Sent: 24/10/2022 4:18:28 PM
Subject: FW: DA2022/1516 - Alterations and additions to residential developmt - Retaining walls, decking, associated landscape works and tree removal, Pty: 30 Herbert Avenue, Newport
Attachments: Submission - 30 Herbert Avenue, Newport.pdf;

**RE: DA2022/1516- ALTERATIONS AND ADDITIONS TO RESIDENTIAL DEVELOPMENT -
RETAINING WALLS, DECKING, ASSOCIATED LANDSCAPE WORKS AND TREE REMOVAL.**
PPTY: 30 HERBERT AVENUE (SUBJECT SITE)

Figure 1: Ensuite Window

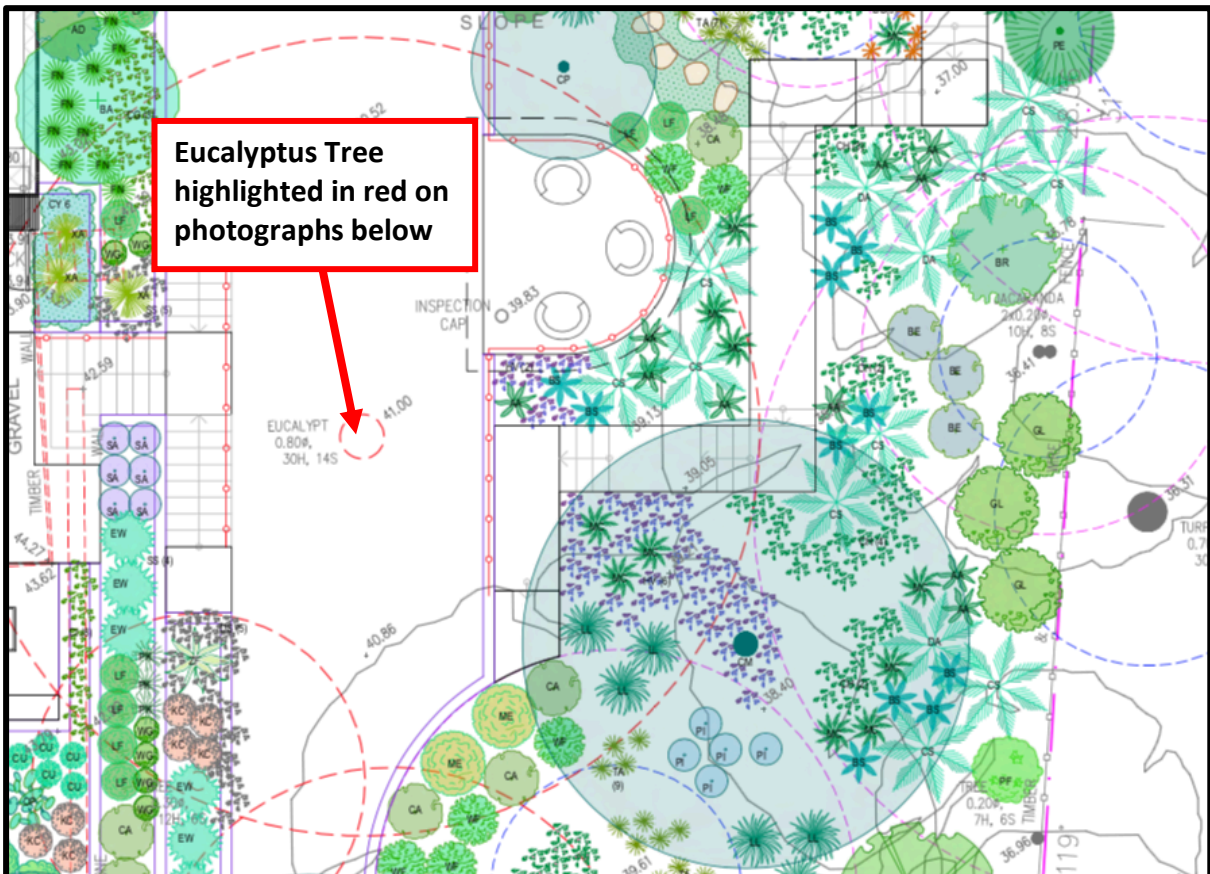
As evidenced in the photographs below, the proposed elevated seating area will have a direct line of site into the ensuite and bedrooms of my Clients' property. I note that the proposed elevated seating area will be located forward and to the west of the Eucalyptus Tree highlighted in **red** the photograph (which is to be removed) and will therefore have a clear line of site into my Client's

property. It is also unclear as to whether the tree highlighted in yellow is to be removed, if so, the potential for privacy impacts will be even greater. I note that the tree highlighted in yellow is not identified within the Arborist Report as being proposed to be removed and we would like confirmation as to whether it is being retained.

In light of the above assessment and in order to provide greater surety in relation to potential privacy impacts, we request that this elevated seating area be removed from the proposed development. Should Council to determine that the elevated seating area is worthy of approval, we seek the imposition of a Condition of Consent requiring a privacy screen to be installed along the northern edge of the proposed elevated seating area in accordance with Clause C1.5 Visual Privacy of Pittwater 21 Development Control Plan, noting the following control contained within this Clause; *“Elevated decks and pools, verandahs and balconies should incorporate privacy screens where necessary and should be located at the front or rear of the building.”*
